GLENWOOD TRAFFIC CALMING MEETING #1

DISCUSSION SUMMARY

Date: August 12, 2020

Do you support device #1 Curb Extension?
(Multiple Choice)

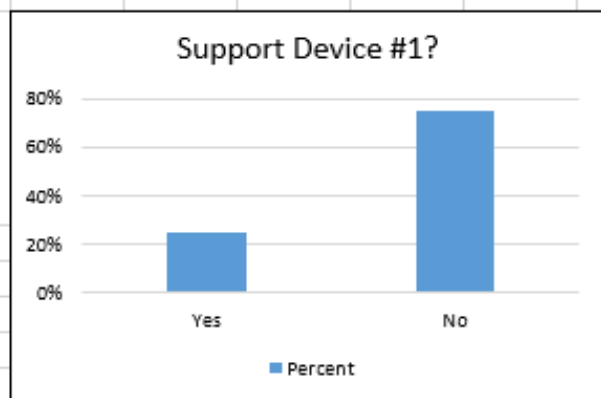
Responses		
	Percent	Count
Yes	25%	1
No	75%	3
Totals	100%	4

Post Meeting Note: This device was kept and shown to incorporate the participants concerns surrounding the existing foliage.

Do you support a raised device between Override and Exmoor? (Multiple Choice)

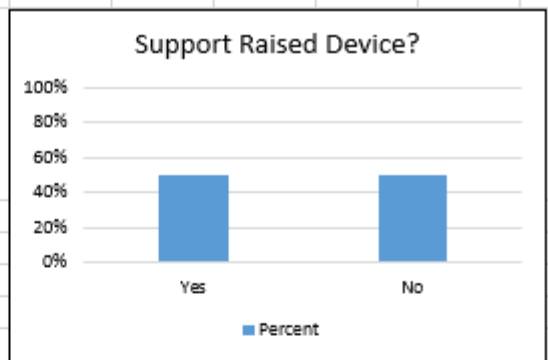
Responses		
	Percent	Count
Yes	50%	2
No	50%	2
Totals	100%	4

Post Meeting Note: Based on polling results, input and engineering judgement a speed table has been added to the Preliminary Plan.

Do you support device #2 Residential Traffic Circle? (Multiple Choice)

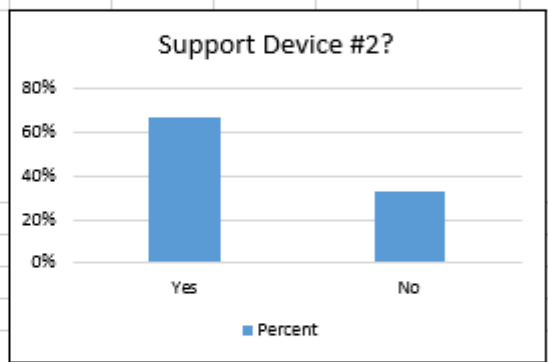
Responses		
	Percent	Count
Yes	67%	2
No	33%	1
Totals	100%	3

Post Meeting Note: Based on polling results, input and engineering judgement this device was kept and is on the Preliminary Plan.

Do you support a raised device on Glenwood between Exmoor and Warwick? (Multiple Choice)

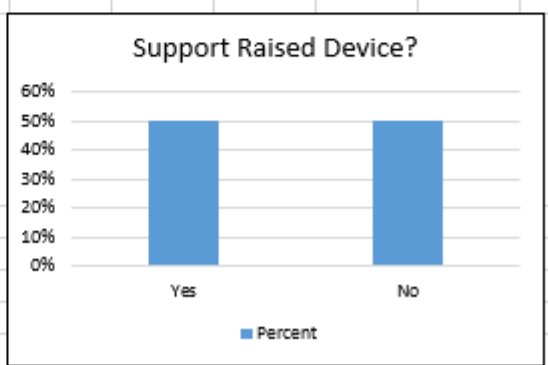
Responses		
	Percent	Count
Yes	50%	2
No	50%	2
Totals	100%	4

Post Meeting Note: Based on polling results, input and engineering judgement a speed table has been added to the Preliminary Plan.

Do you support device #3 Residential Traffic Circle? (Multiple Choice)

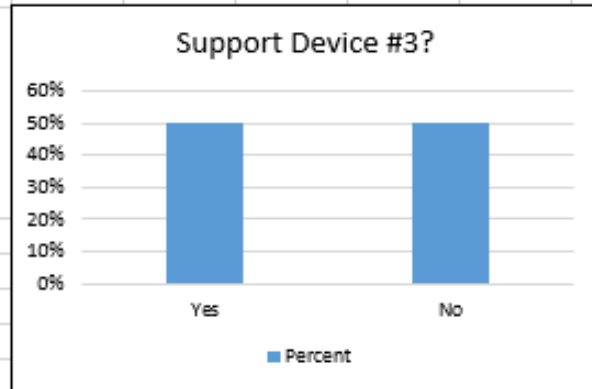
Responses		
	Percent	Count
Yes	50%	2
No	50%	2
Totals	100%	4

Post Meeting Note: Based on polling results, input and engineering judgement this device was kept and is on the Preliminary Plan.

Do you support a raised device on Glenwood between Warwick and Washtenaw? (Multiple Choice)

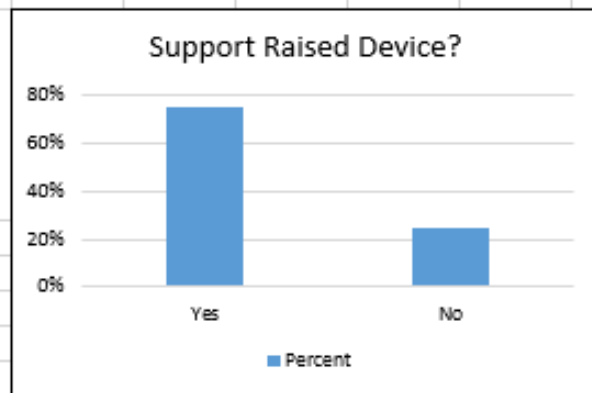
Responses		
	Percent	Count
Yes	75%	3
No	25%	1
Totals	100%	4

Post Meeting Note: Based on polling results, input and engineering judgement a speed table has been added to the Preliminary Plan.

Do you support device #4 Median Island? (Multiple Choice)

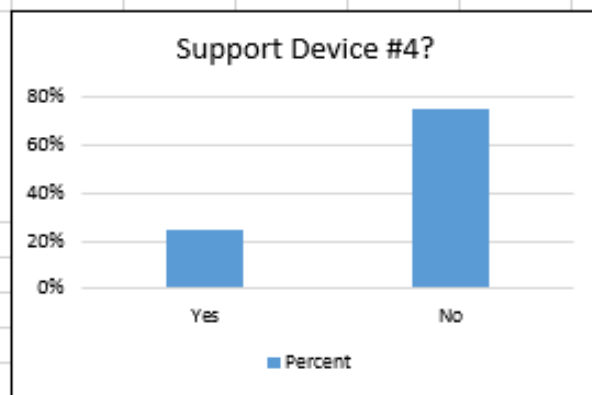
Responses		
	Percent	Count
Yes	25%	1
No	75%	3
Totals	100%	4

Post Meeting Note: Based on polling results, input and engineering judgement this device was removed from the Preliminary plan.

Appendix B: Annotated Starter Idea

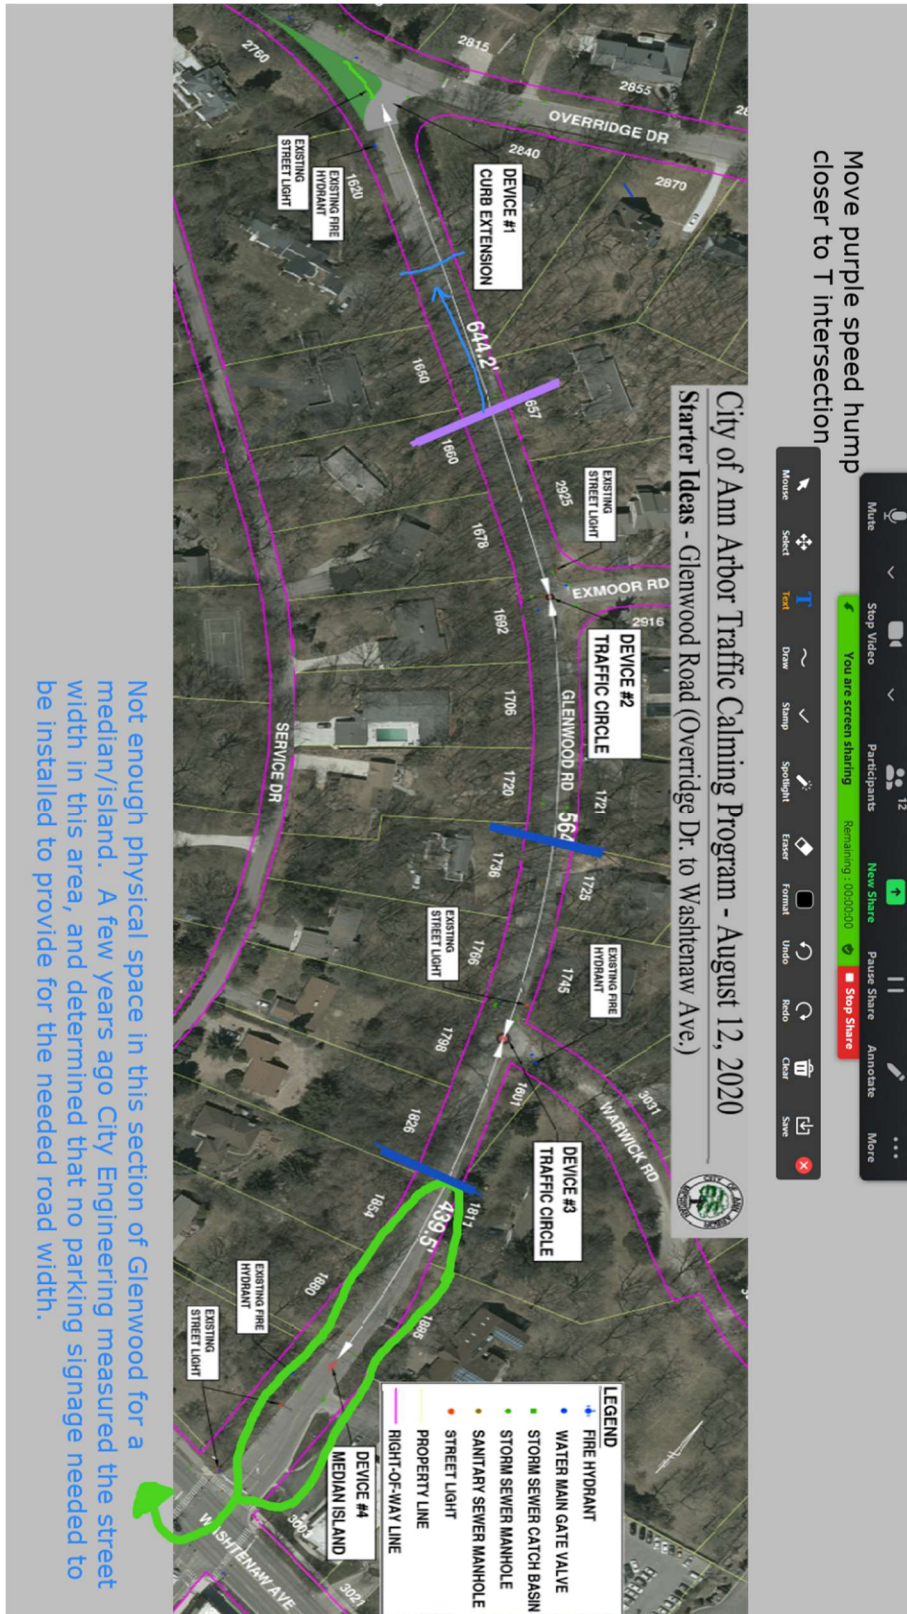
The median/island at Override/Glenwood is maintained by neighborhood volunteers. ~ 2 yrs. ago the City replaced the dead trees, and this required a fair amt. of work/time to accomplish. (chat)

Will the traffic circles be large enough so that people must go around them? The road is not wide so with the circle you would just have to go straight into it. Is it going to be a narrow (small diameter) island?

I don't think device 1 will slow down because people just go after they make the turn onto Glenwood. (live)

I'm worried device 1 will put pedestrian traffic in more harm. In winter the driving conditions cause cars to slide up onto the island, this change could cause people siding up onto lawns. Can we put a speed hump closer to Override intersection to slow drivers down more?

It seems like a waste to take away the island already at the intersection of Override and Glenwood because we have worked hard on making it look aesthetically pleasing. (live)

- a. *Post Meeting Note: If the Curb Extension was installed it would incorporate the existing foliage into its new configuration. This has been addressed and a visual aid added on Meeting #2 Preliminary Plan.*

- a. Engineering designers have determined that the proposed traffic circles will fit within the existing road width. Traffic circles are designed at a size that physically and visually tightens the corridor by narrowing the street width. The design will allow enough space for emergency vehicles to get through.

Post Meeting Note: The design provides 18' of vehicle width on all sides of the traffic circle.

- a. *Post-meeting note: This will remain a 3-way stop, so all approaching vehicles will have to stop to turn. Stop sign locations would be evaluated for relocation to provide better sightline of the other legs of the intersection.*

- a. *Post-meeting note: Installation of the curb extension, and the resulting reconfiguration of the intersection, would result in narrowed street width. Narrower streets have several safety effects, including slowing traffic down and reducing the distance pedestrians would need to cross the intersection. The revised plan has placed an additional speed table close to the Override and Glenwood Intersection.*

- a. *Post-meeting note: Installation of the curb extension at Override and Glenwood would allow the existing trees and landscape to remain. Those features from the existing island would not be removed.*
